ADDENDUM | No. 3

PROJECT	Tea Law Enforcement Center Tea, South Dakota Project #: 23292.00.00	
BID DATE	3:30 PM CT	April 20, 2021
BID LOCATION	Tea City Hall 600 E. 1 st Street Tea, SD 57064	
ISSUE DATE	April 16, 2021	
NOTICE	Failure to acknowledge all addenda in the BID may cause rejection of the BID. See Instructions to Bidders.

S-102R

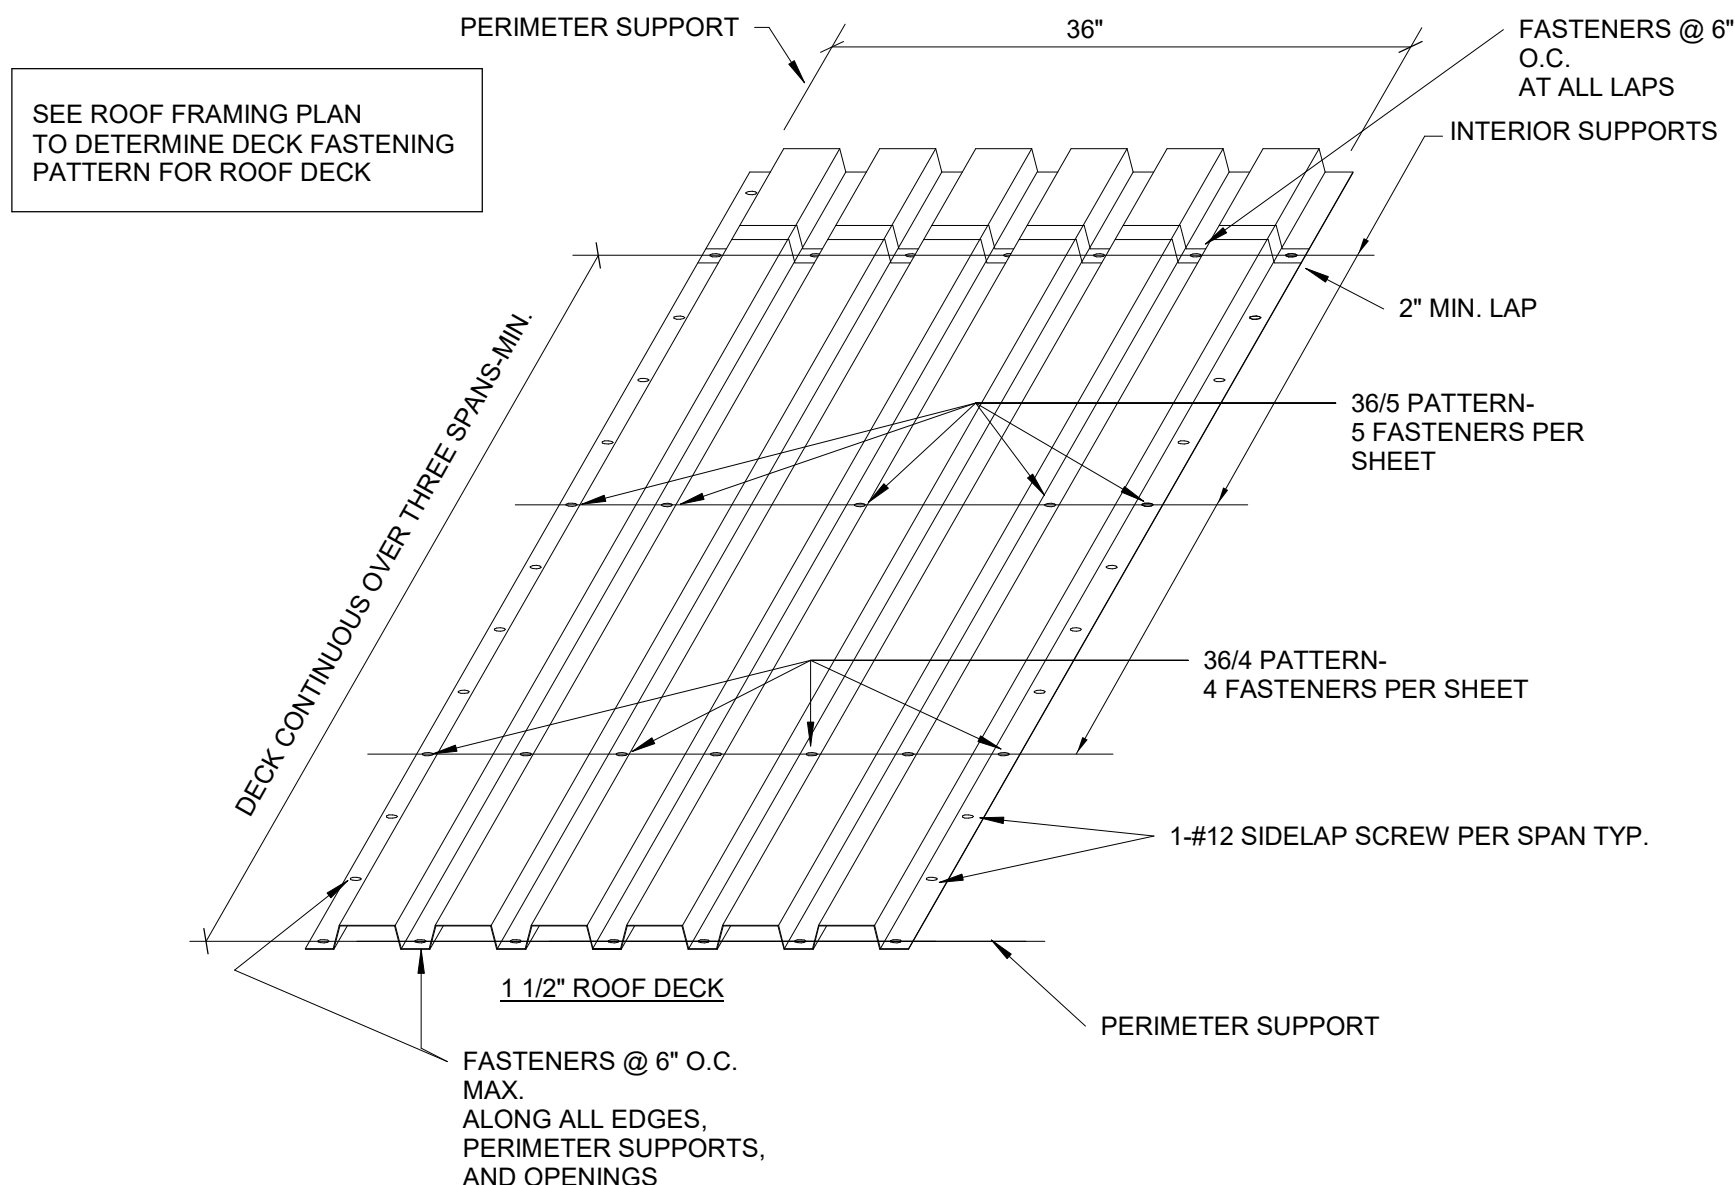
New Drawing Sheet S-102R – Structural Framing Plan - Admin – Refer to Attachment for new Drawing indicating additional Detail call-offs.

7
S-907
METAL STUD BYPASS CLIP
SCALE = 1 1/2" = 1'-0"

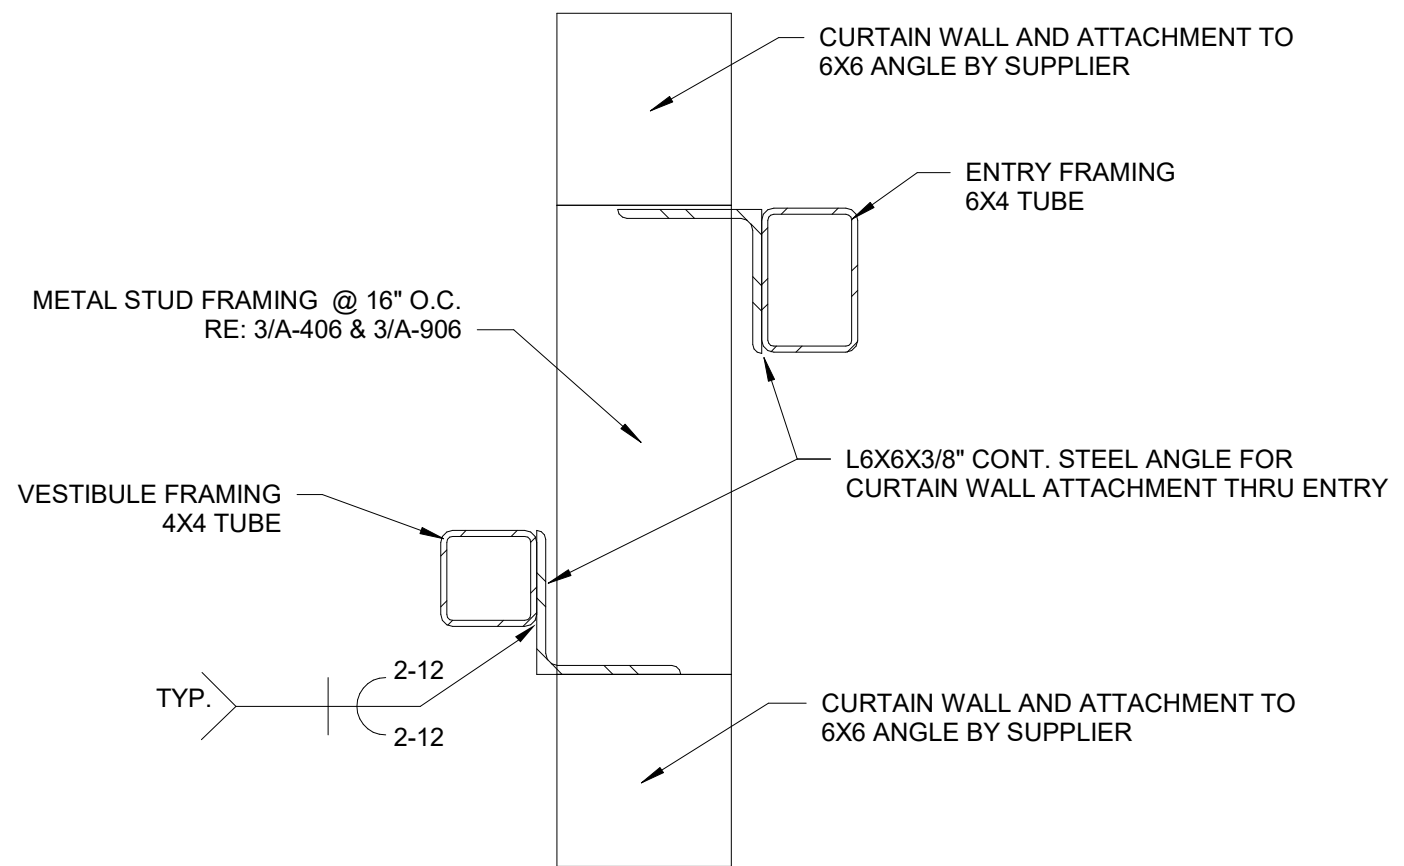
“Stud attachment to structure shall be bypass framing with 14 gauge ClarkDietrich Universal Bypass Clips, or approved equal. Stud screws to be installed approximately 1-inch from top of slot to allow for downward deflection of beams. #14 shouldered screws shall be approved by the manufacturer for use in the bypass clip. Powder-actuated fasteners shall be 0.157-inch Hilti X-U, or approved equal, and be placed at indentations scribed on the short leg of the Universal Bypass Clip.”

9
S-907
GARAGE MECH. ROOM ROOF DETAIL
SCALE = NONE

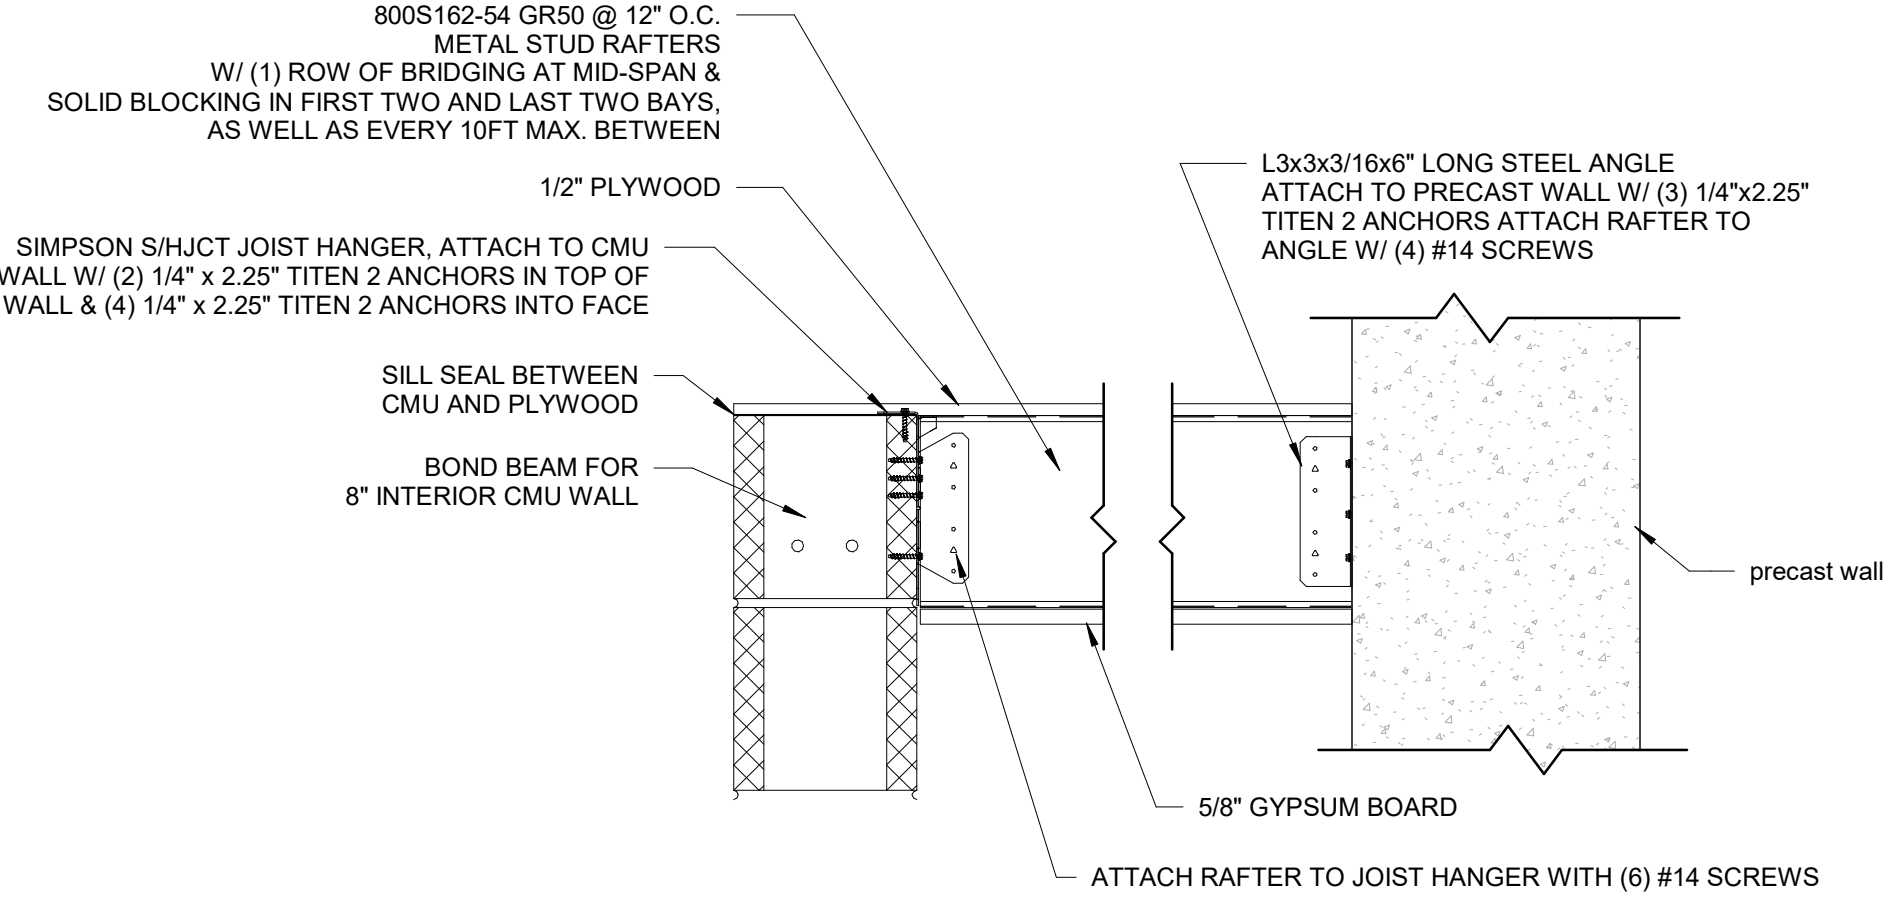
General Note O: to read as: Ceiling structure for Mechanical Room, RE: S-907R for Detail.

FIGURE NO :
3-1

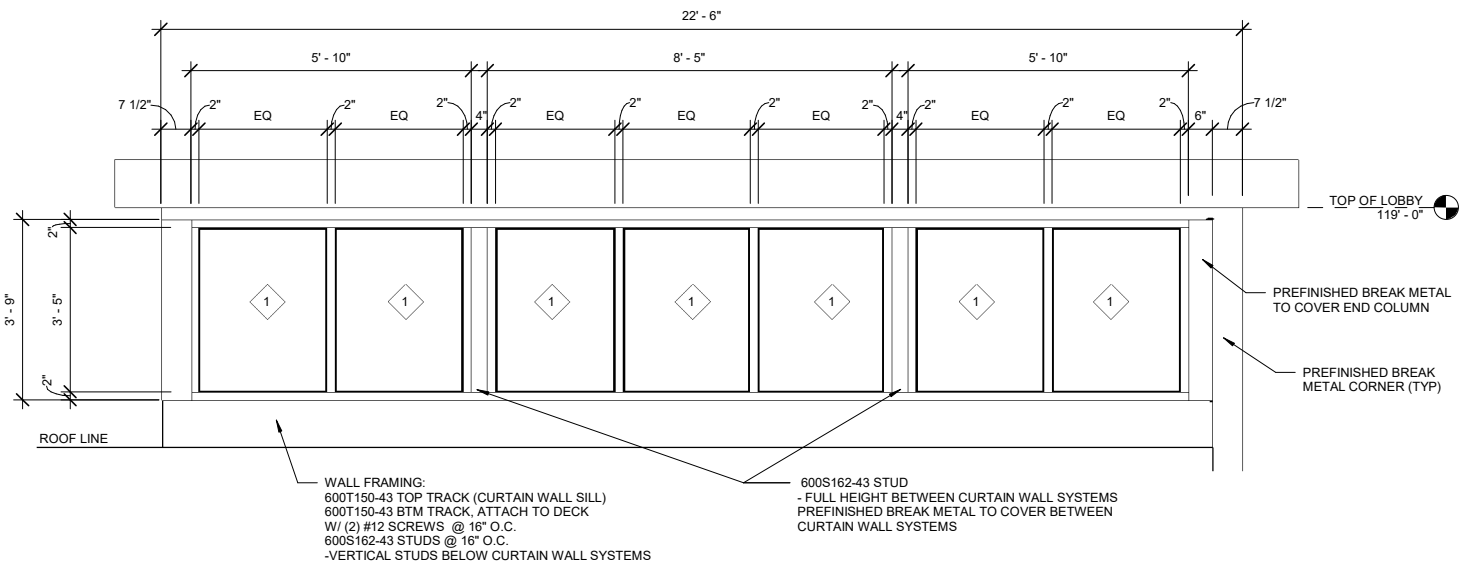
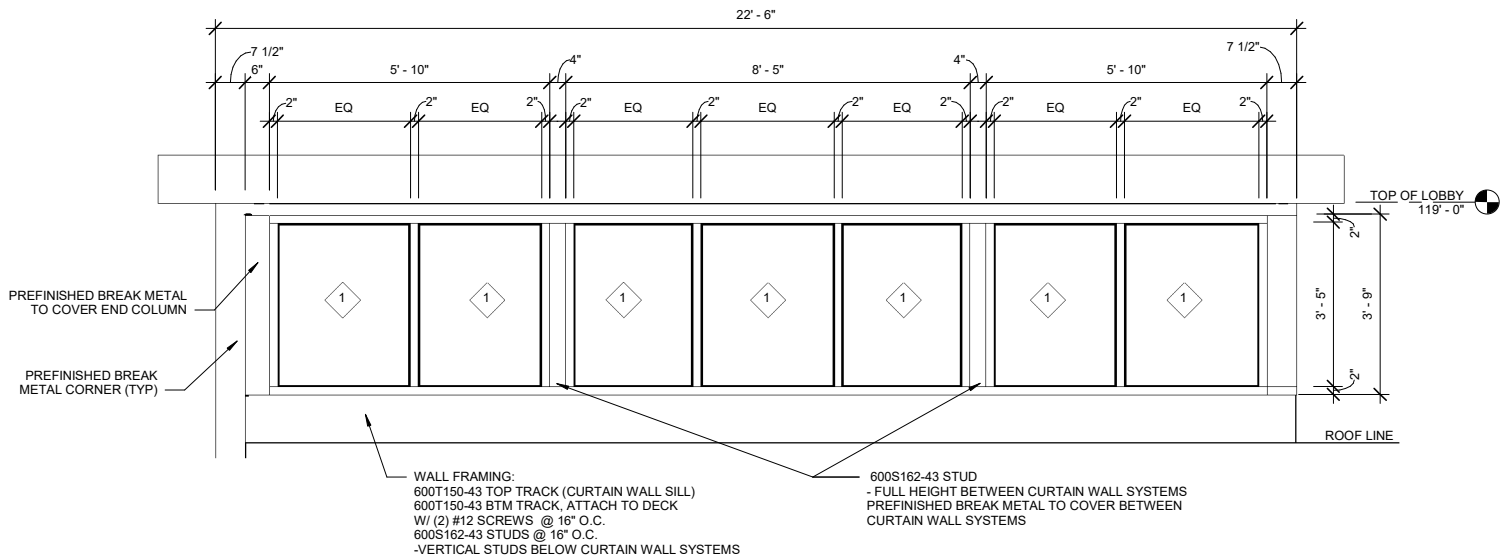
Add New Curtain Wall Details 3 & 4. Refer to Attachment (Figure 3-1) for new layout of curtain wall systems and wall framing requirements for the upper east and west curtain wall systems.
